CONTRACT NO. DE-AC06-96RL13200 -- REPORT ON THE DEFENSE NUCLEAR FACILITIES SAFETY BOARD (DNFSB) RECOMMENDATION 2000-2 PHASE II ASSESSMENT OF THE FIRE PROTECTION SYSTEMS AT THE CENTRAL WASTE COMPLEX (CWC)

**Report on the
DNFSB Recommendation
2000-2 Phase II Assessment
of the Fire Protection Systems at the
Central Waste Complex**

ESD-PH2-CWC-02-001

Figure 1: CWC Building 2402WF Water Supply and Sprinkler Demand Curve

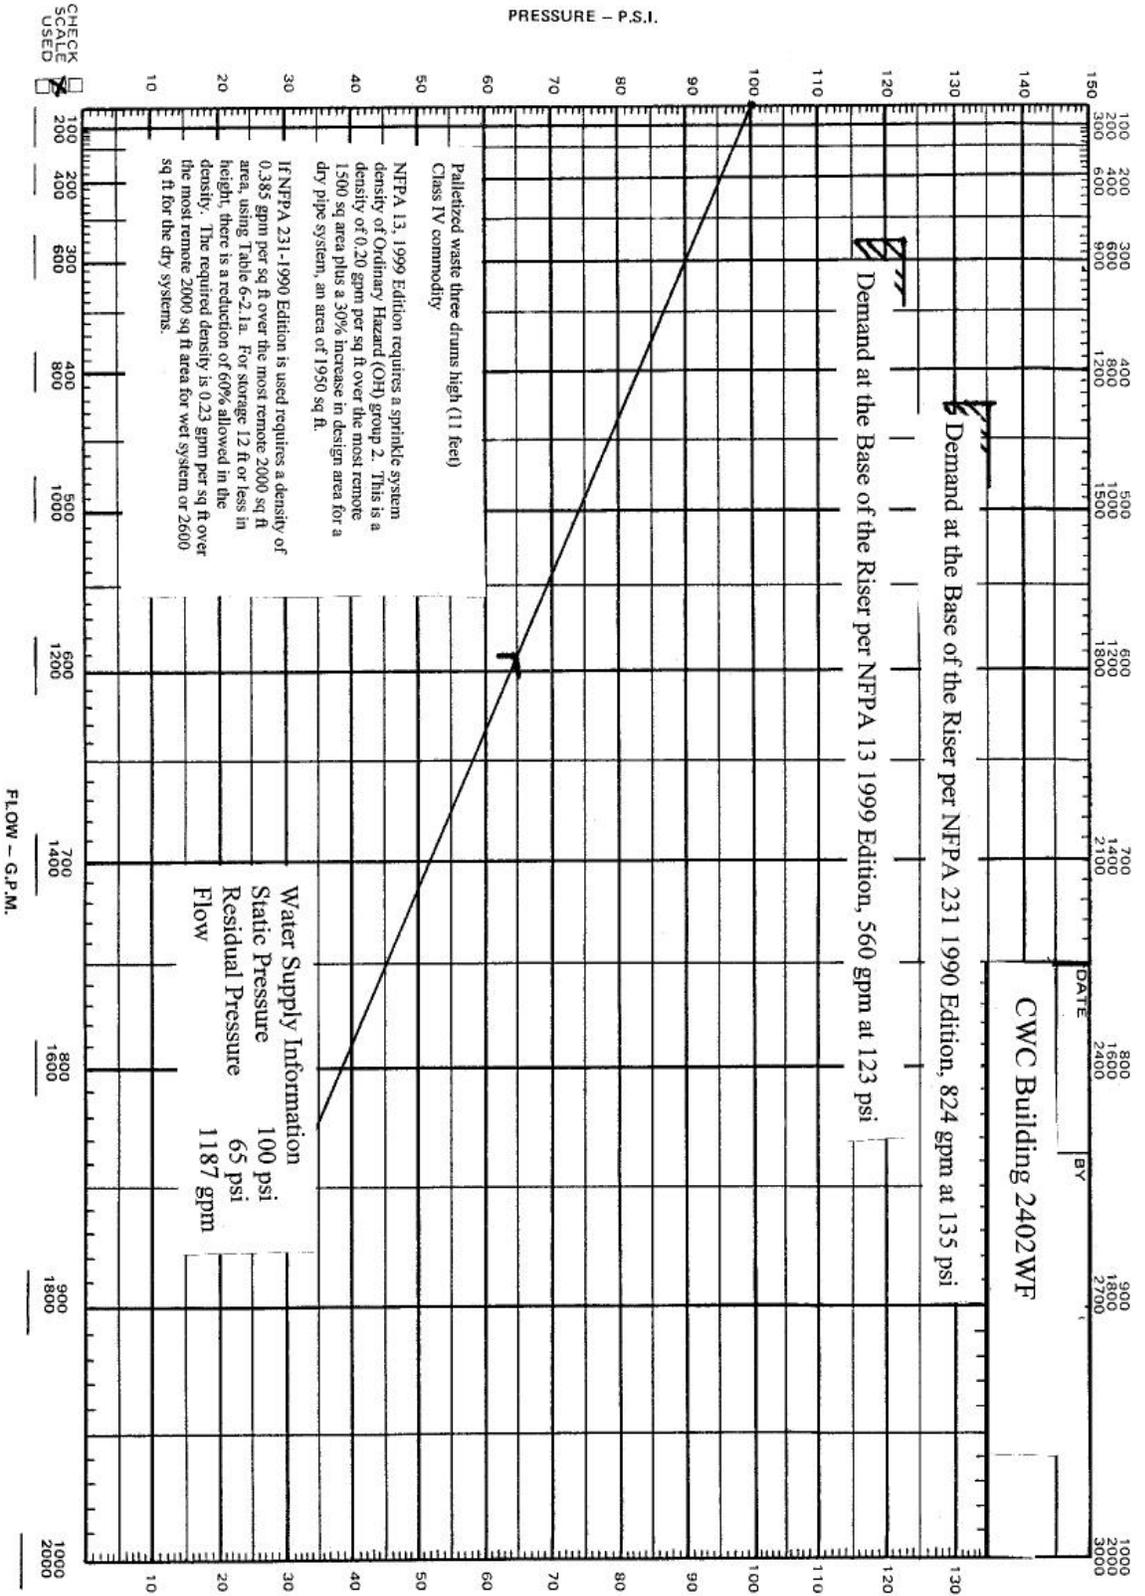
Additional reviews and calculation were done for the sprinkler systems in the 2402W type buildings. The sprinkler systems are four-inch dry pipe systems using ordinary hazard pipe schedule, about 125 sq ft head spacing per head using 165 degree F rated heads. The storage is drummed waste (a Class IV commodity per the Facility FHA) three drums high, 11 feet. This type of storage requires a sprinkler system that can provide a sprinkler density of Ordinary Hazard (OH) group 2 as defined by NFPA 13, 1999 Edition. This requires a sprinkler density of 0.20 gpm per sq ft over the most remote 1500 sq ft area. In addition, a 30% increase in design area is required for the dry systems which gives an area of 1950 sq ft. Hydraulic calculations using the HASS program were done at this density. HASS determined that the required flow at the base of the riser is 560 gpm at 123.4 psi and 1060 gpm at 134 psi at the loop. This latter flow includes 500-gpm allowances for fire department hose streams. In addition, hand hydraulic sprinkler calculations were done at this density to verify this information. The required flow at the base of the riser from this calculation was determined to be 562 gpm at 119.73 psi and 1062 gpm at 129 psi at the loop. This latter flow includes 500-gpm allowances for fire department hose streams. This is within the tolerance differences expected by both calculations.

If the 1990 Edition of NFPA 231, Standard for General Storage, is used to determine the required automatic sprinkler density, the required flow is much greater than the above flow. Using Table 6-2.1a, the required density to protect a Class IV commodity is 0.385 gpm per sq ft over the most remote 2000 sq ft area. In addition, a 30% increase in design area is required for the dry systems. However, the density can be reduced in accordance with Figure 6-2.2. For storage 12 ft or less in height, there is a reduction of 60% allowed in the density. The required density is 0.23 gpm per sq ft over the most remote 2000 sq ft area for wet system or 2600 sq ft for the dry systems. The required flow at the base of the riser for a dry system is 823.9 gpm at 134.7 psi and 1329 gpm at 155 psi at the loop. This latter flow includes 500-gpm allowances for fire department hose streams.

The water supply cannot provide the required flows. The water supply has a static pressure of 100 psi with a residual pressure of 65 psi at a flow of 1187 gpm based HFD test done January 25, 2002. See Figure 1.

The sprinkler systems as installed can only provide about half of the required sprinkler system density. With this reduced density, a fire starting in the palletized storage may not be controlled. This could lead to failure of the building steel and the building could fall to the ground. The fire could continue to burn in an uncontrolled manner.
